**Addendum No. 1
to the Bidding Documents**

**Shuttle Meadow Pump Station Rehabilitation
Plainville, Connecticut**

Issued November 16, 2023

TOPOGRAPHIC SURVEY
SHUTTLE MEADOW PUMP STATION
TOWN OF PLAINVILLE
SHUTTLE MEADOW AVENUE
PLAINVILLE, CONNECTICUT

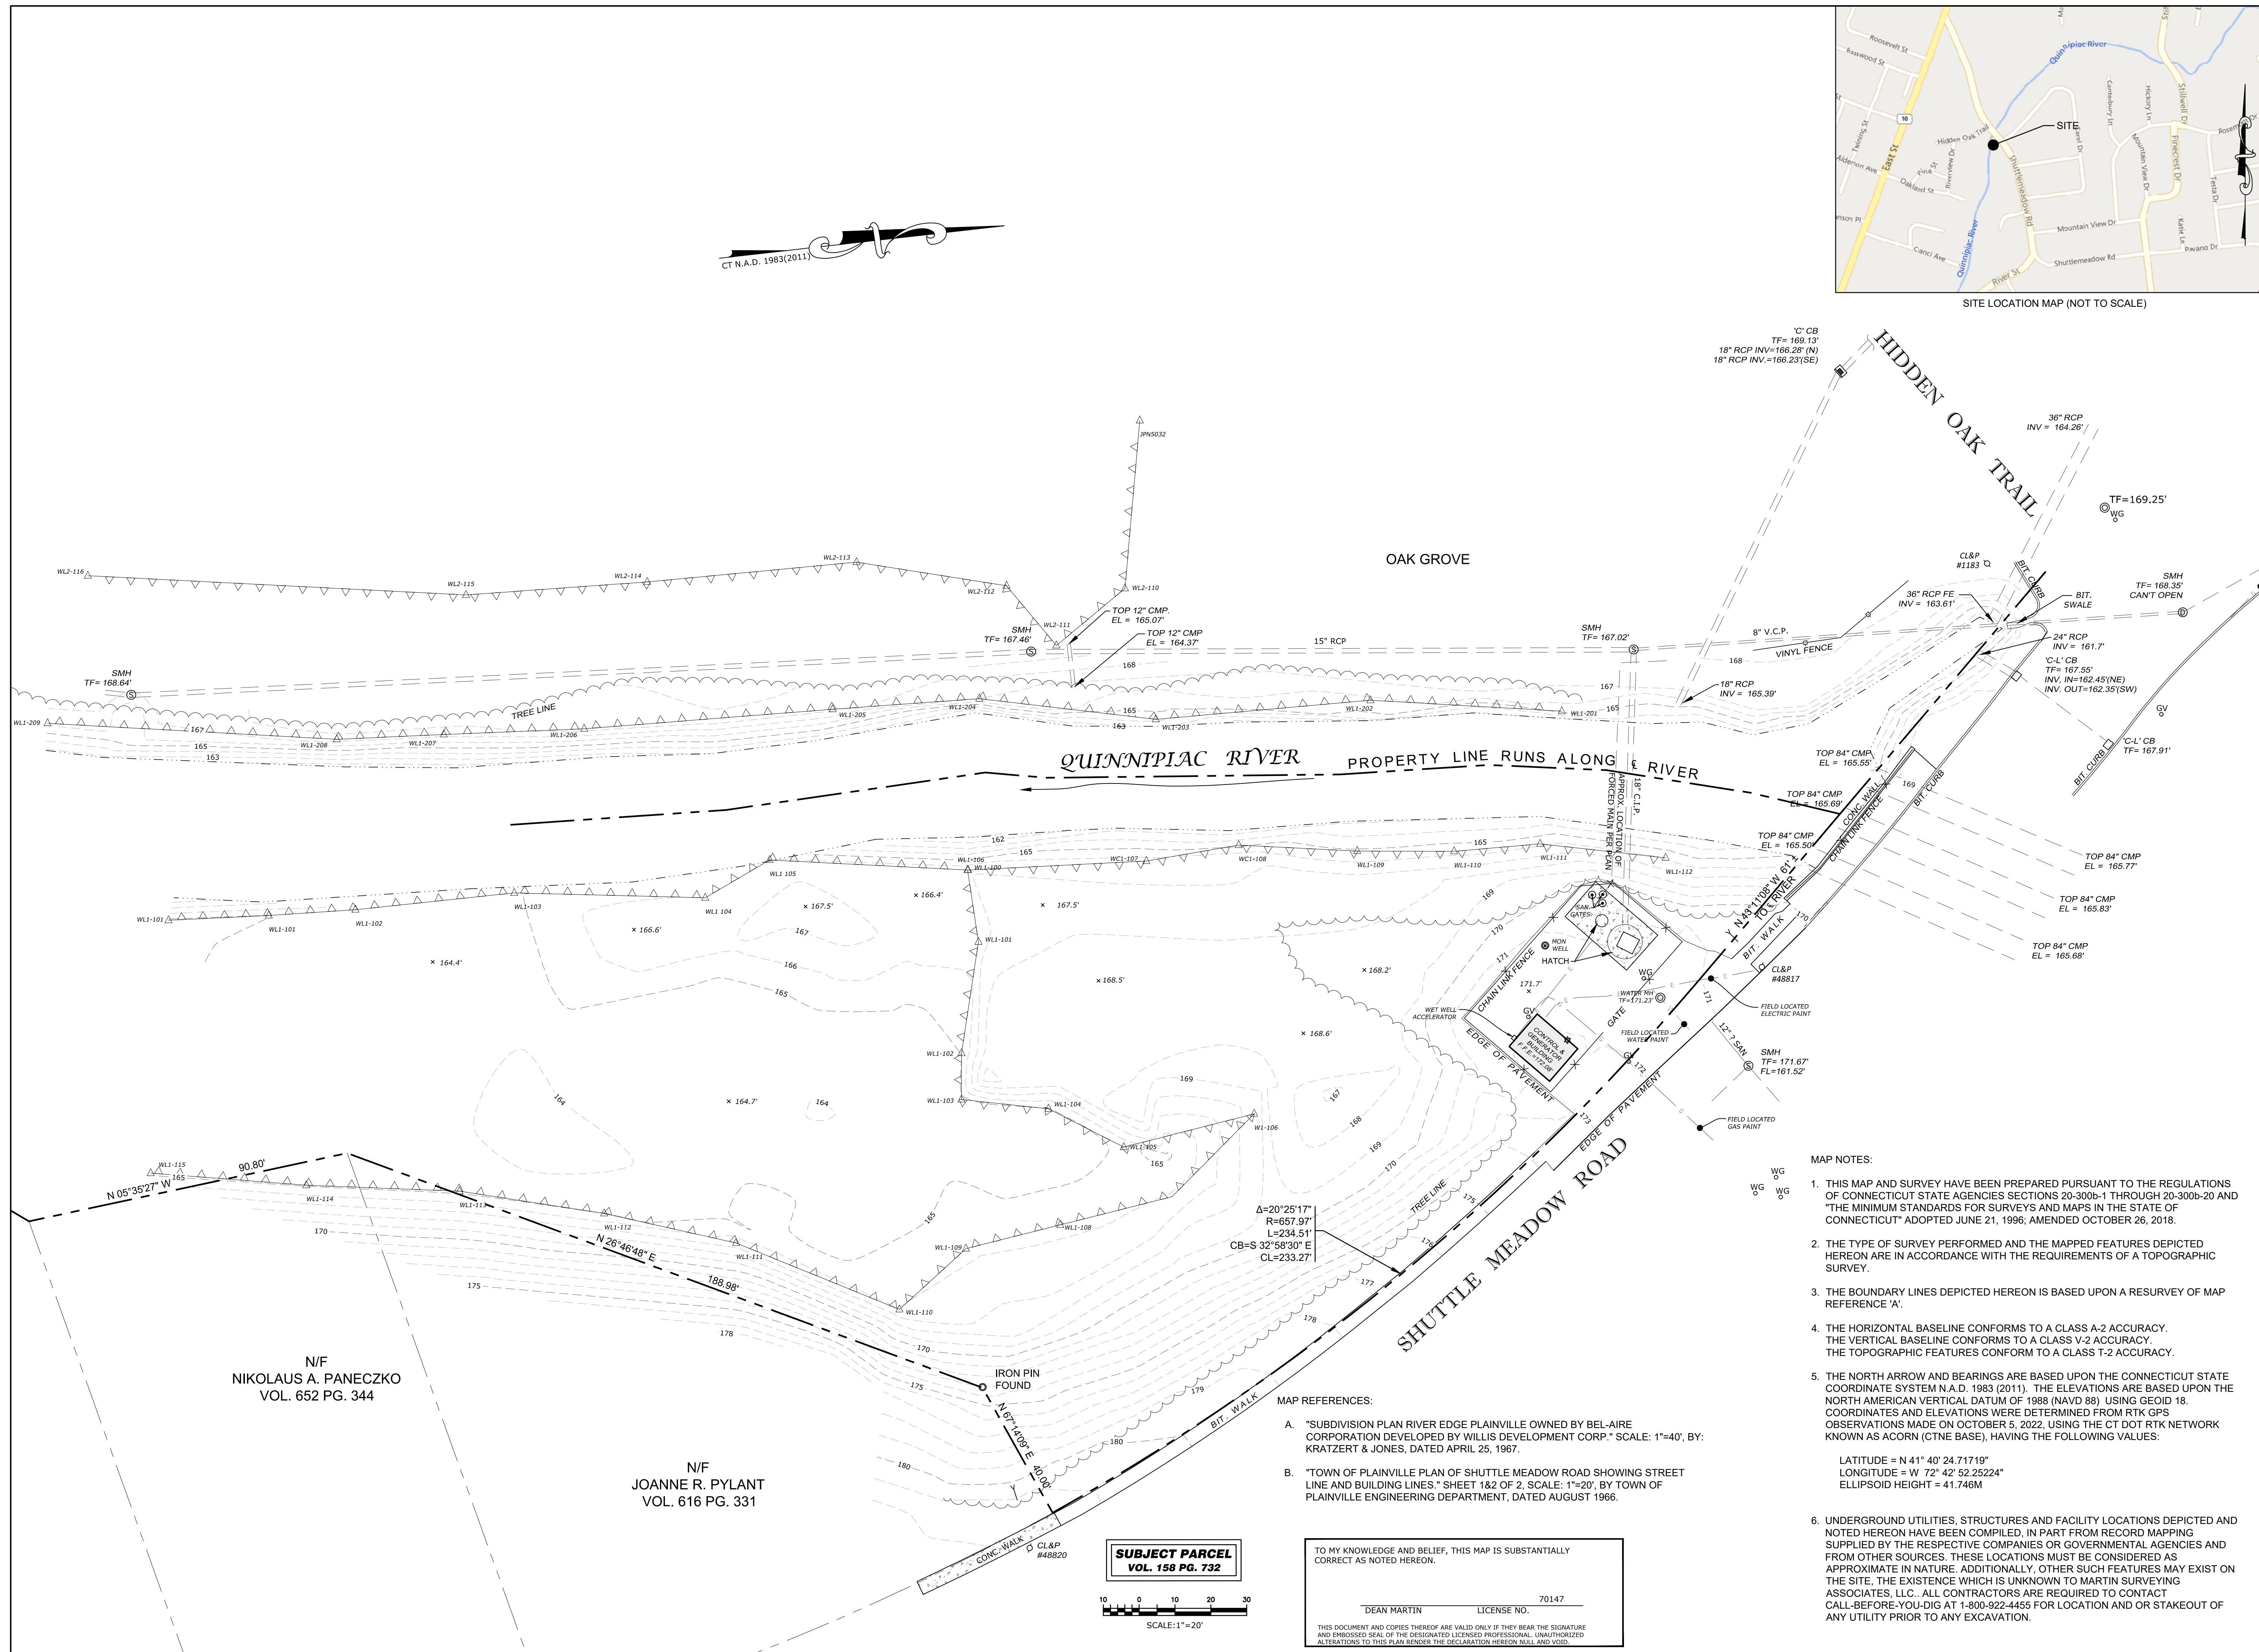
1. **Question:** Will Tighe & Bond mark out the property line prior to bidding?
Some trees will need to be cut down to allow for crane access.

Answer: Please refer to the attached survey. Individual trees that the Contractor proposes removing shall be marked by the Contractor for the Town's review and approval. The Town does not object to selective removal of Town-owned trees as needed for crane access.
